Ordinary Meeting of Council

ITEM 9.1 DA.2025.0211 - 38A FORSTER STREET BUNGENDORE -

CONSTRUCTION OF A DWELLING HOUSE - TWO

ATTACHMENT 1 SECTION 4.15 ASSESSMENT REPORT - DA.2025.0211 - 38A

Image 1 – Plans of

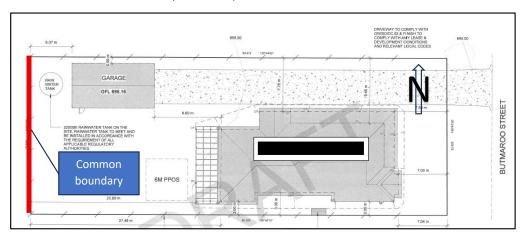
The rear boundary of our property is common to the proposed development site. Image 1 below shows a plan view of our property with the western boundary marked in red, spanning the full 22m width of our block. Image 2 shows a satellite photo of surrounding properties with red lines to illustrate the location of common boundaries (not to scale).

showing common boundary with development site (red line)

Image 5 – showing shed height of 2.4m in contrast to existing trees. The proposed development would occupy the space represented by the red dotted line and all the trees will be removed and replaced by a timber paling fence at 1.8m height.

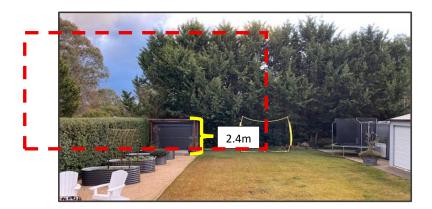
The inconsistencies in the submitted plans regarding the number of storeys to be built are noted (prelodgement application vs submitted plans).
